TP193825 BACKSPACE MAGNET ASSEMBLY

OBJECT: To provide more reliable operation and simplify adjusting procedure.

SECTION 573-117-800.01

FIGURE 1. MANUAL AND POWER DRIVE BACKSPACE MECHANISM
FOR CHADLESS OR FULLY PERFORATED
TAPE (LATEST DESIGN)

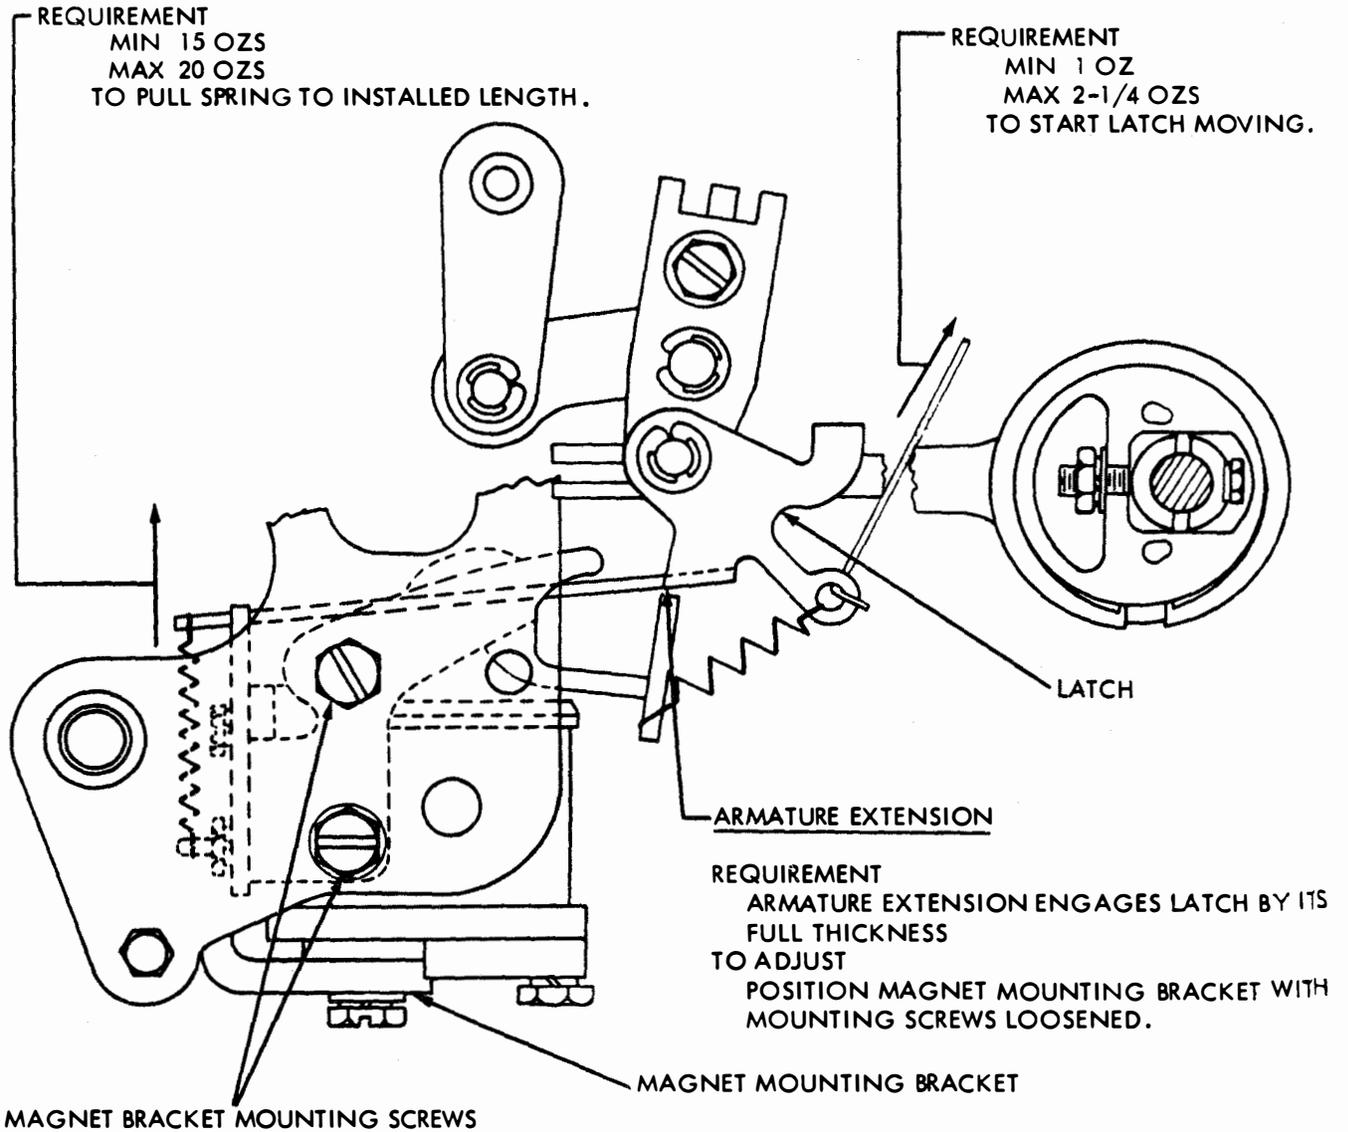
CHANGE: 1. The TP159966 backspace magnet assembly used in the backspace mechanism is replaced by the TP193825 backspace magnet assembly.

2. Requirement is added to Section 573-119-700, Section 573-118-700 and Section 573-117-700, after the last adjustment for the backspace mechanism.

REQUIREMENT
MIN 15 OZS
MAX 20 OZS
TO PULL SPRING TO INSTALLED LENGTH.

REQUIREMENT
MIN 1 OZ
MAX 2-1/4 OZS
TO START LATCH MOVING.

REQUIREMENT
ARMATURE EXTENSION ENGAGES LATCH BY ITS
FULL THICKNESS
TO ADJUST
POSITION MAGNET MOUNTING BRACKET WITH
MOUNTING SCREWS LOOSENED.

FIGURE 1. MANUAL AND POWER DRIVE BACKSPACE MECHANISM
FOR CHADLESS OR FULLY PERFORATED
TAPE (LATEST DESIGN)

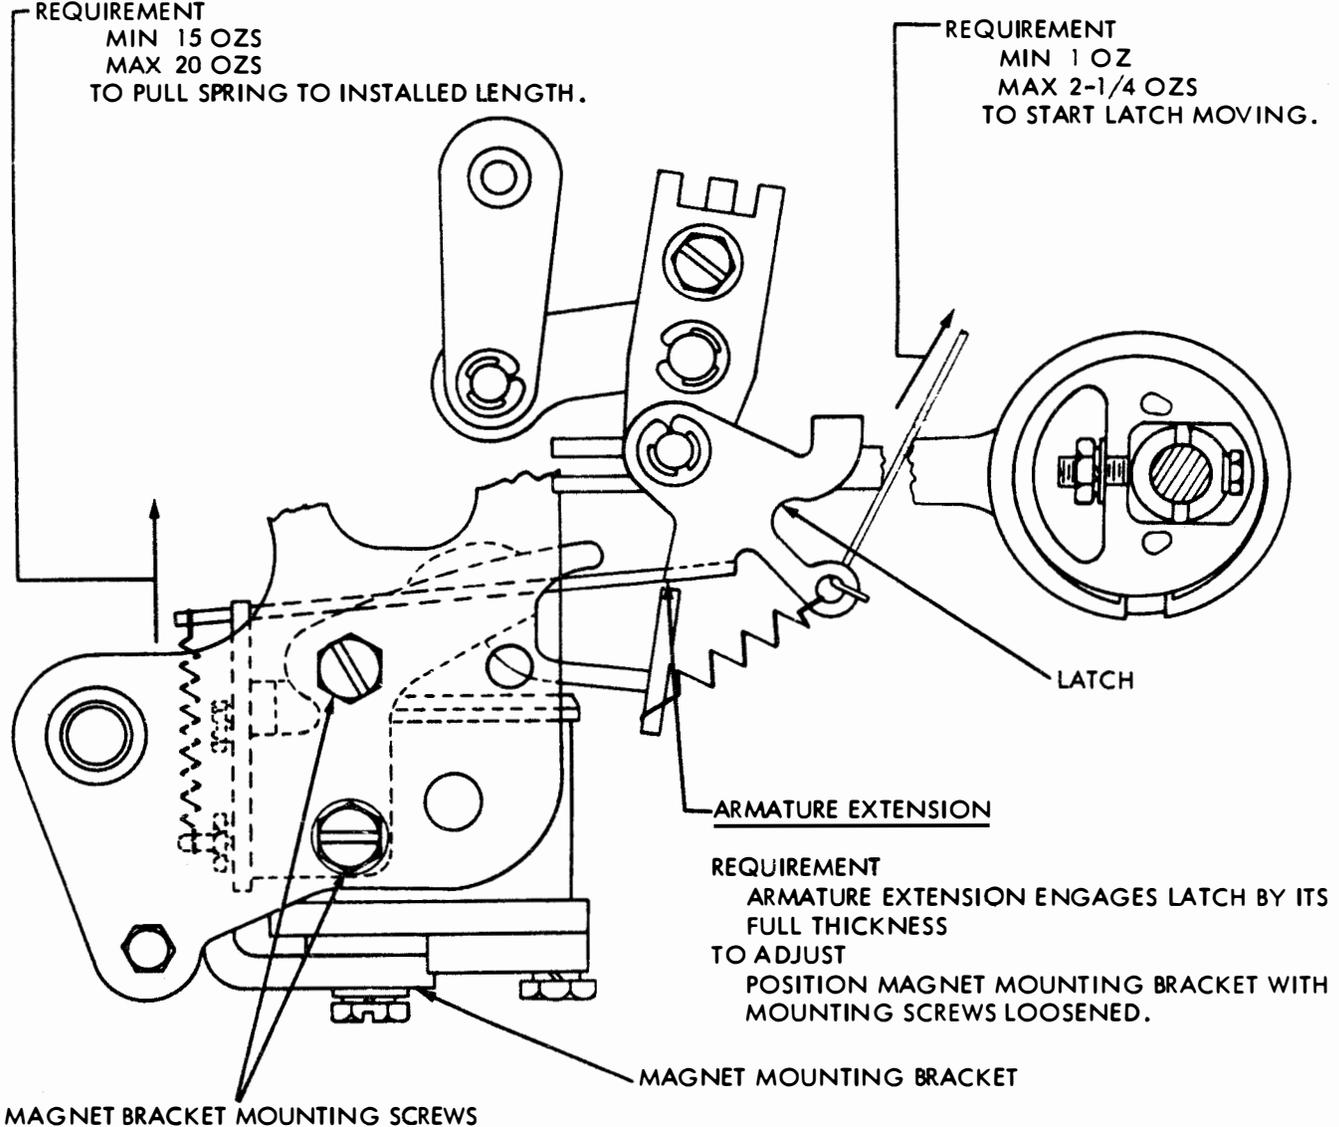
CHANGE: 1. The TP159966 backspace magnet assembly used in the backspace mechanism is replaced by the TP193825 backspace magnet assembly.

2. Requirement is added to Section P34.650, Issue 3 (Plant Series Section 573-119-700); Addendum P34.651, Issue 1 (Plant Series Section 573-118-700); Section P34.660, Issue 3 (Plant Series Section 573-117-700) and Teletype Bulletins 247B, dated May 1962; 250B, dated June 1962; 256B, dated June 1962, after the last adjustment for the backspace mechanism.

REQUIREMENT
MIN 15 OZS
MAX 20 OZS
TO PULL SPRING TO INSTALLED LENGTH.

REQUIREMENT
MIN 1 OZ
MAX 2-1/4 OZS
TO START LATCH MOVING.

REQUIREMENT
ARMATURE EXTENSION ENGAGES LATCH BY ITS
FULL THICKNESS
TO ADJUST
POSITION MAGNET MOUNTING BRACKET WITH
MOUNTING SCREWS LOOSENED.

Fig. 1 — TP144764, TP176700 or TP158000 Base

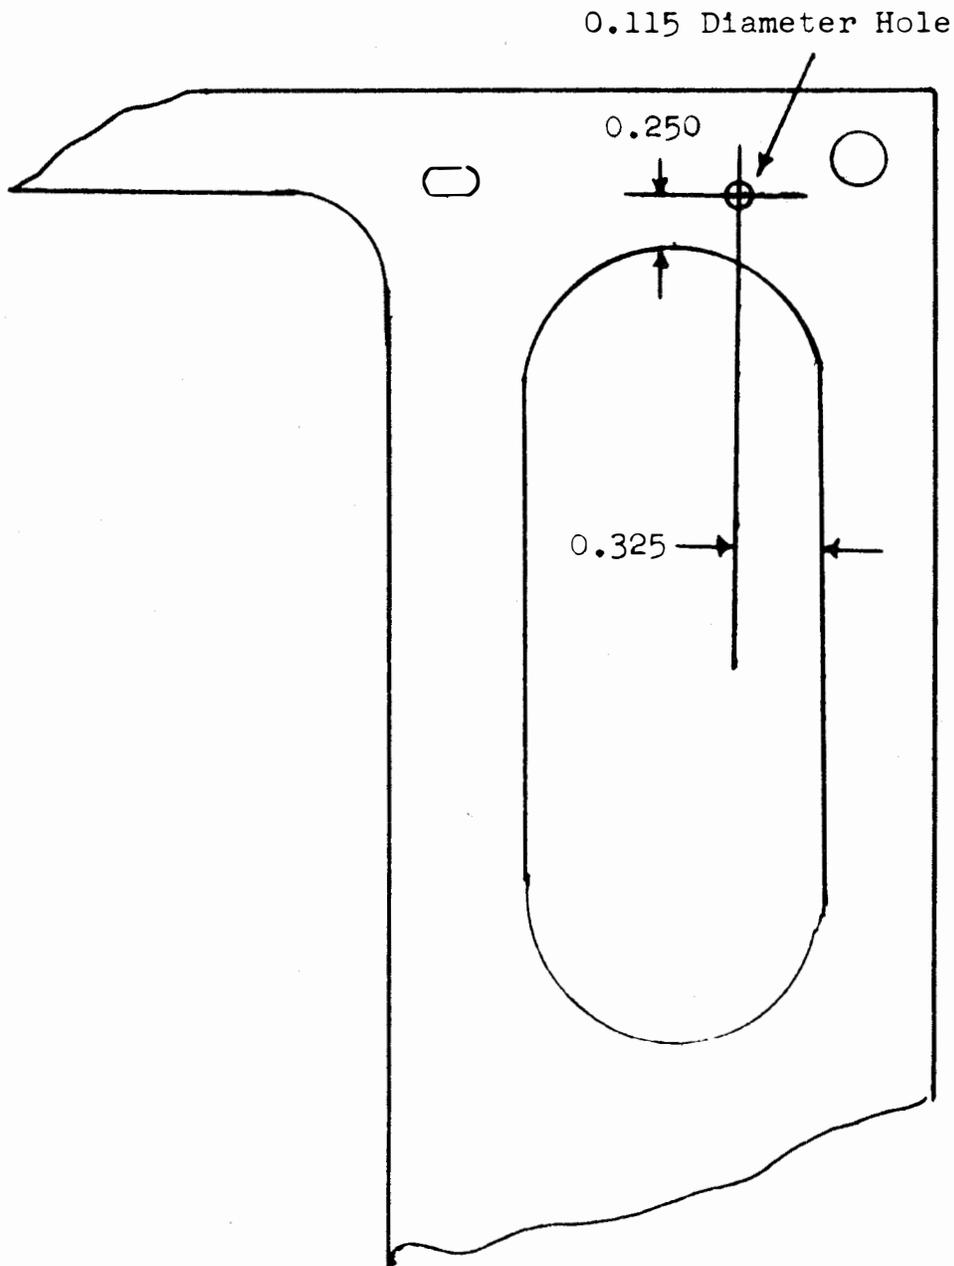
CHANGE: The TP144764, TP176700, and TP158000 bases have been modified by the addition of a 0.115 diameter hole (adjacent to the lower left motor mounting screw) for mounting a terminal tab by means of a self-tapping screw. See Figure 1.
